Addendum No. 2
February 26, 2021

Project: Lincoln High School – C.I.P. Addition and Renovations PD#3311
Sioux Falls, South Dakota

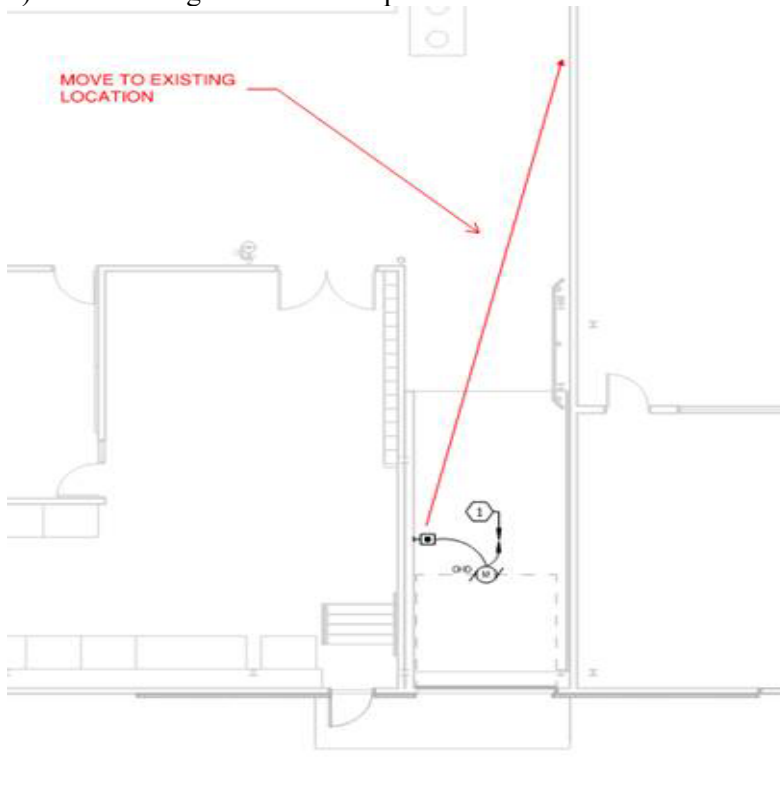
- b) The existing overhead door pushbutton is shown below:

5.11

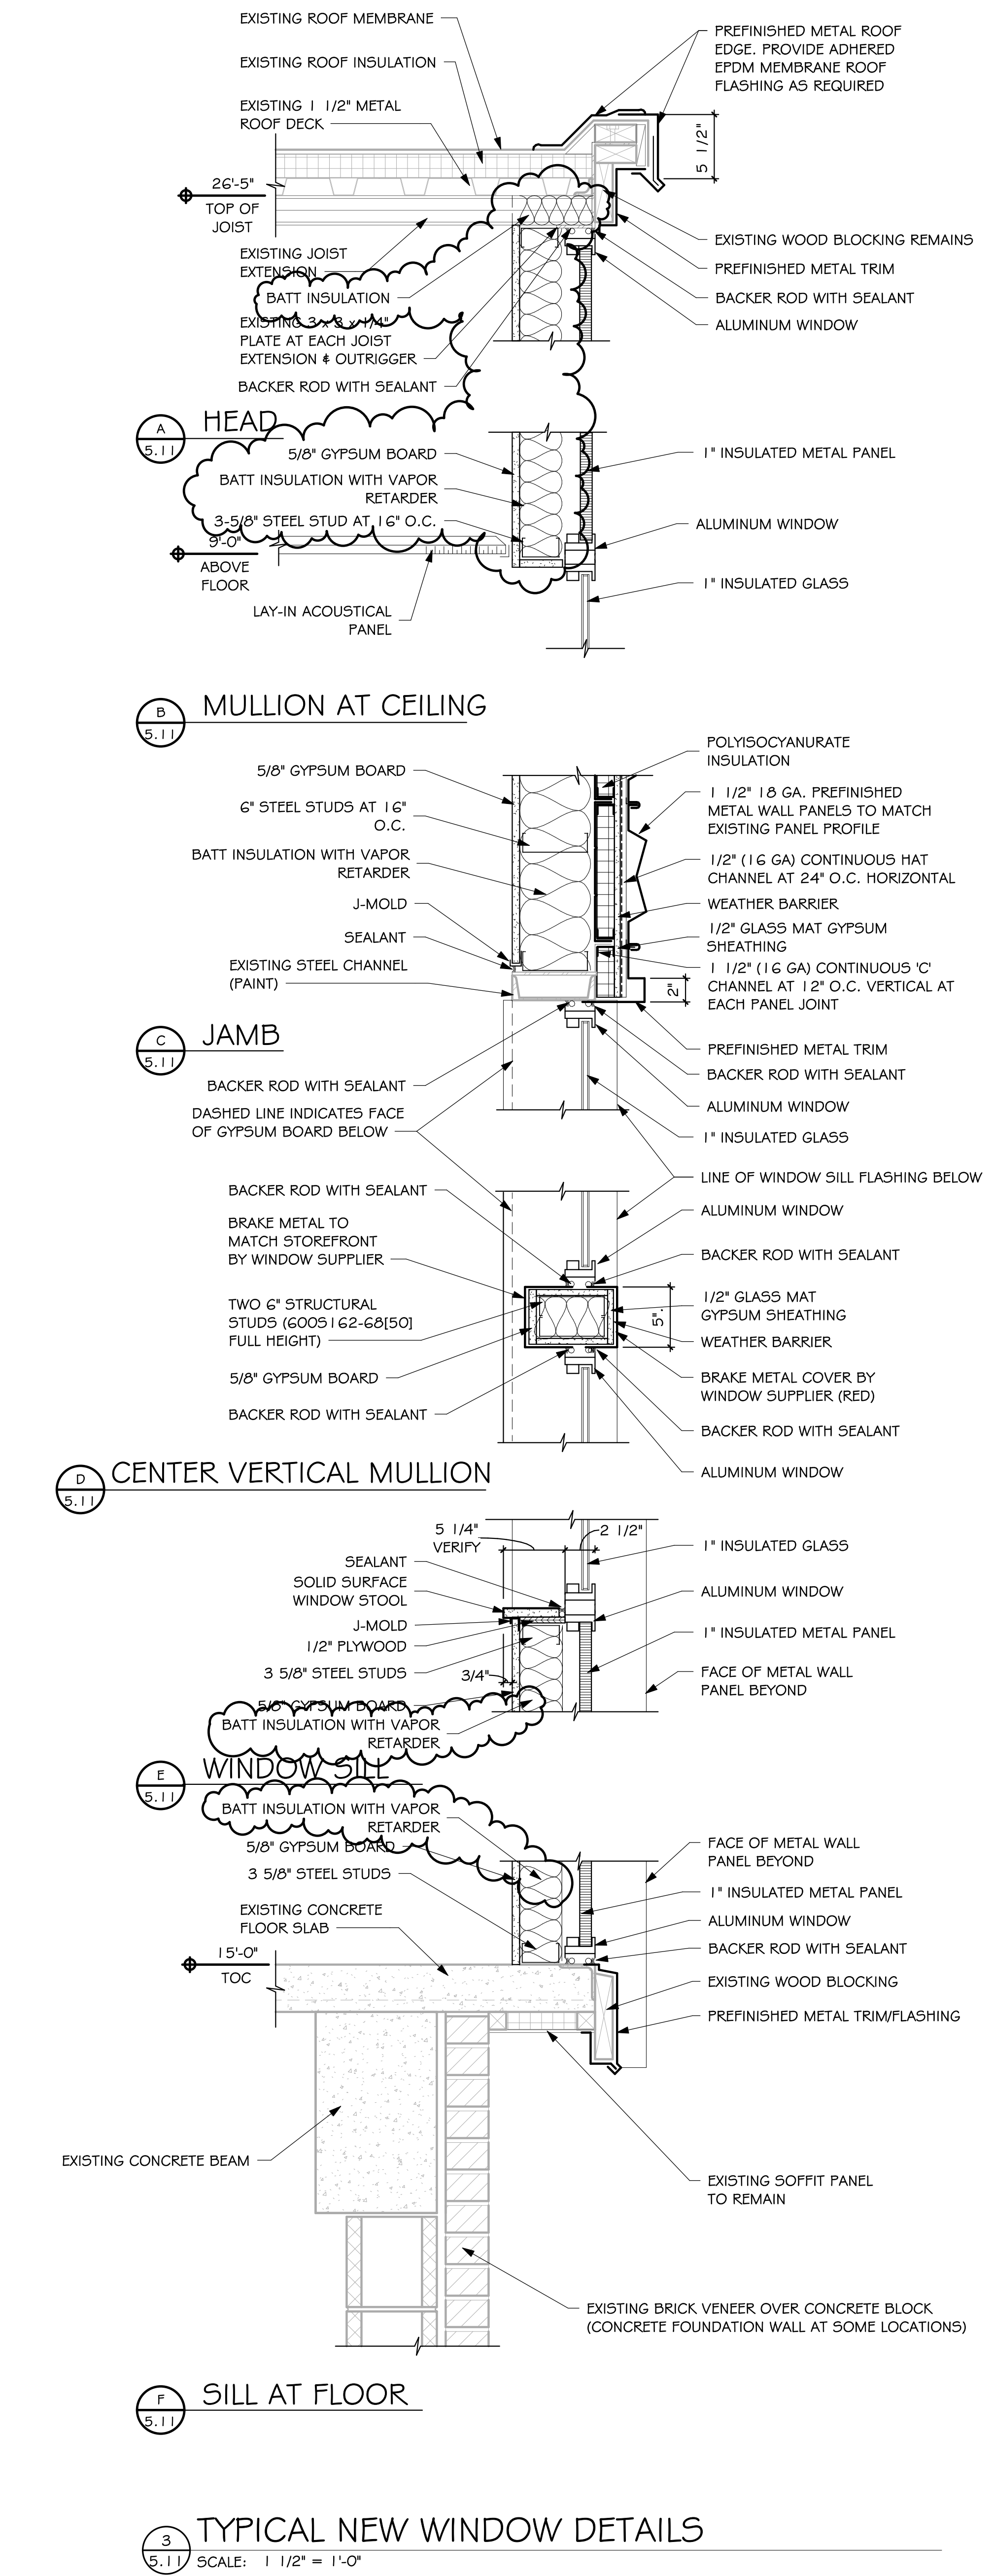
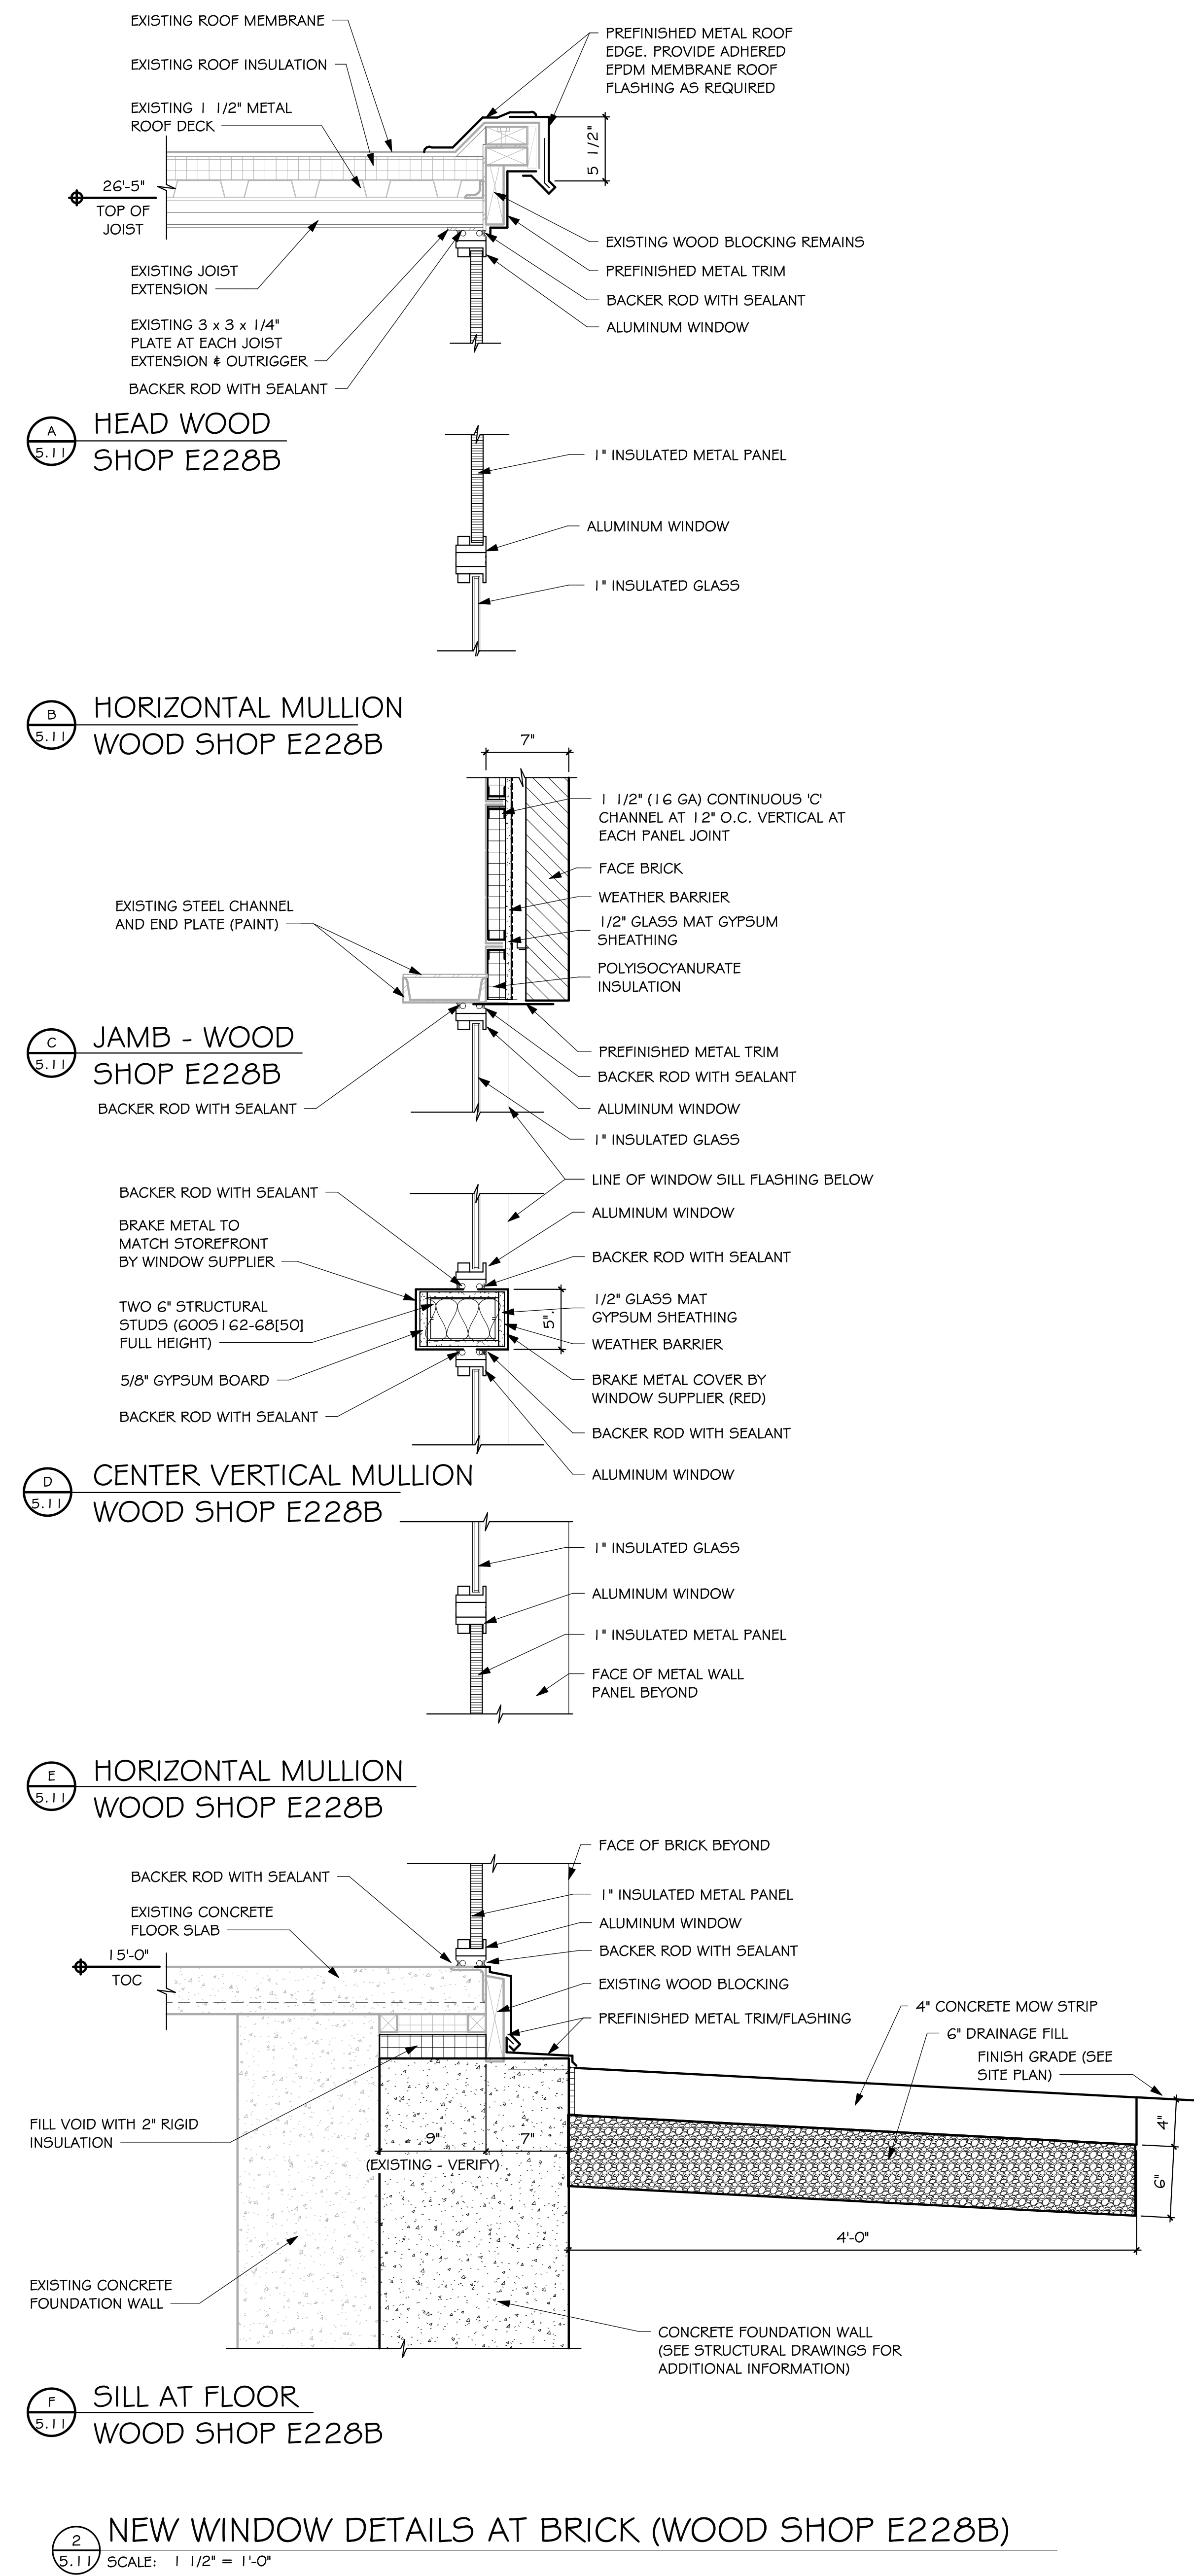
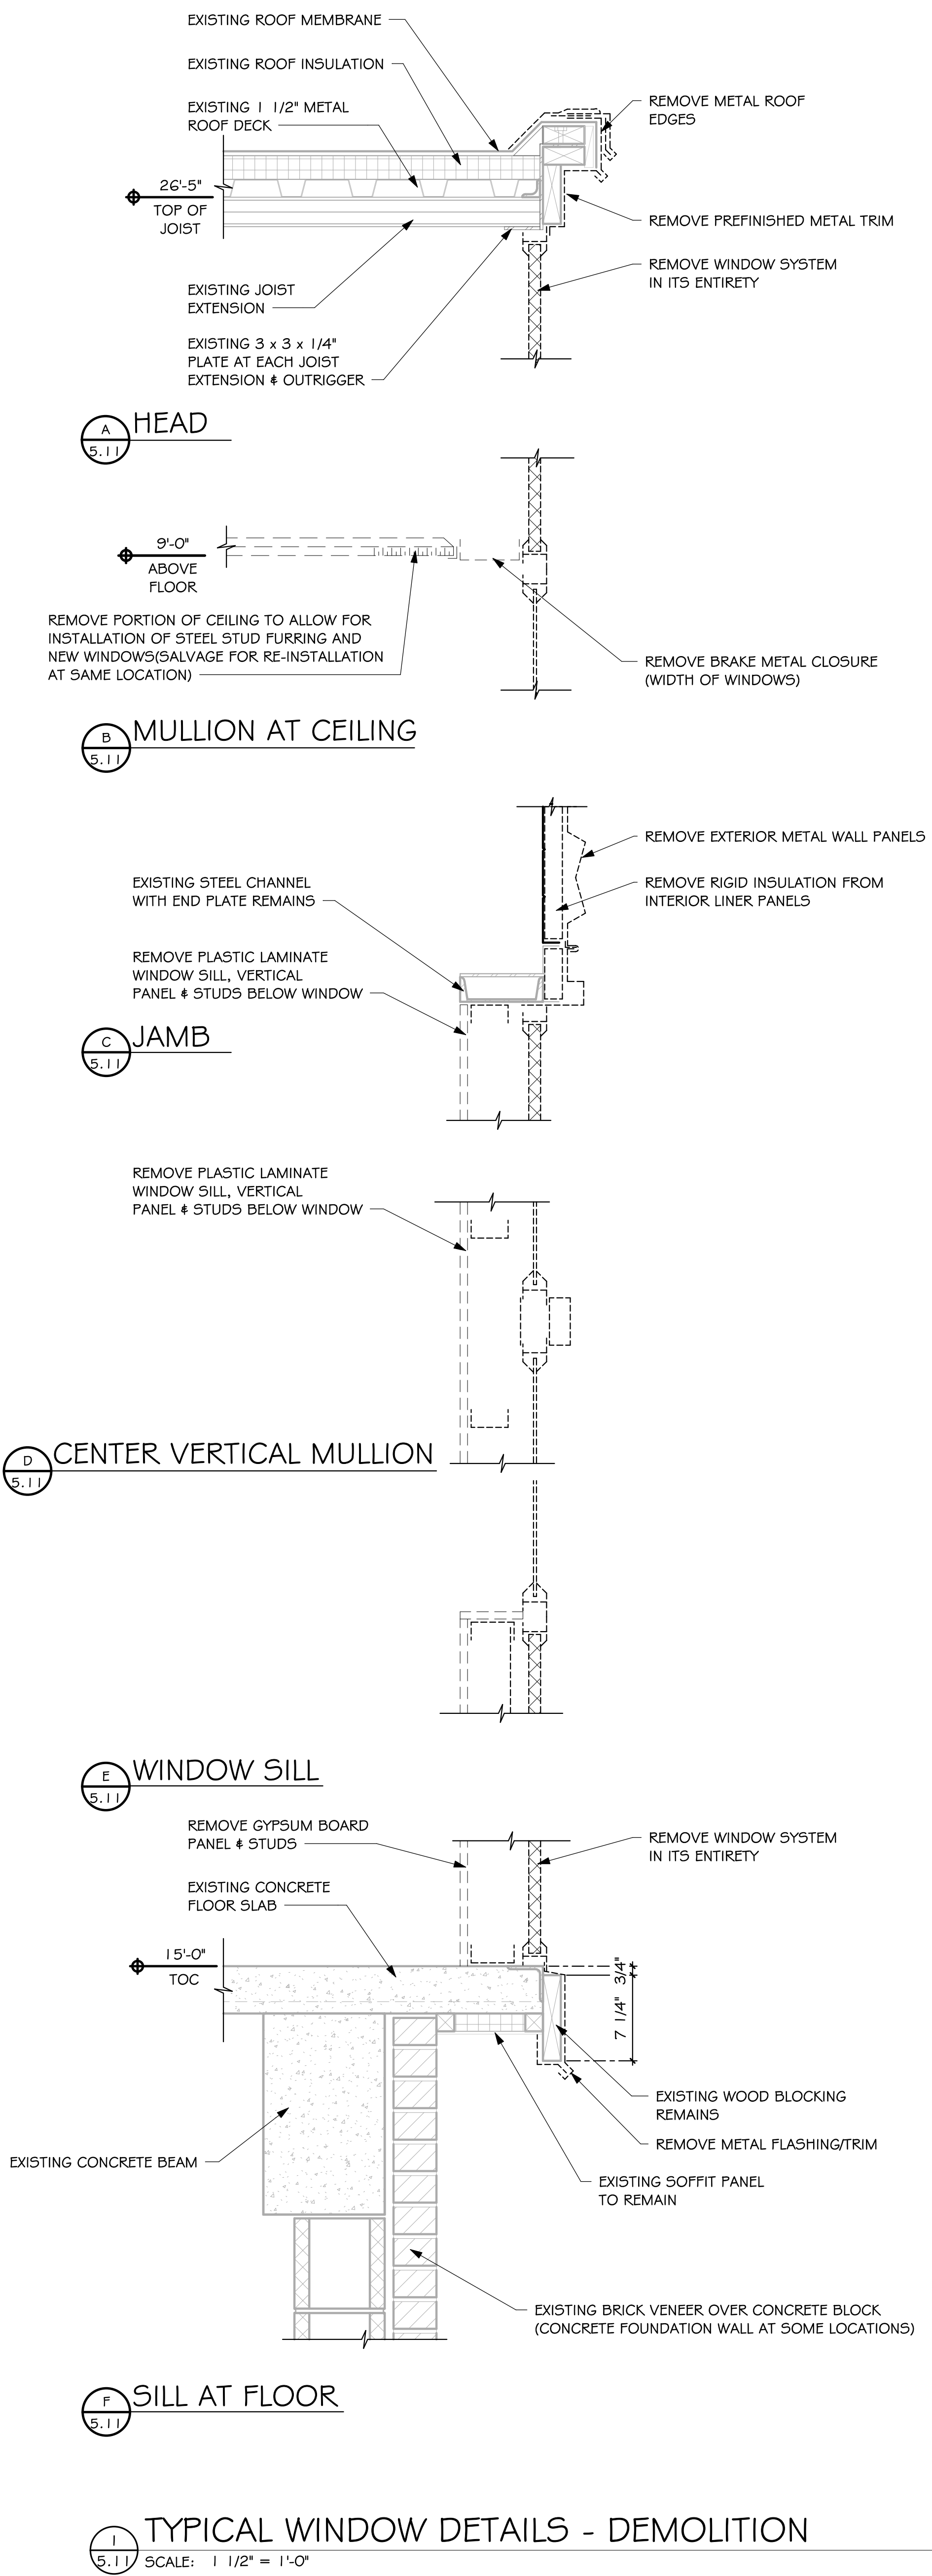
- a) Reference revised drawing Sheet 5.11, revision dated 2-26-21, which is attached to the end of this addendum for revised window detail 3/5.11, Details A, B, D & E (for *new* windows). This Sheet also now bears the Architect's stamp & signature.
 - i) Architectural drawing Sheet 5.11, revision dated 2-26-21, shall replace original drawing Sheet 5.11 dated 2-5-21.
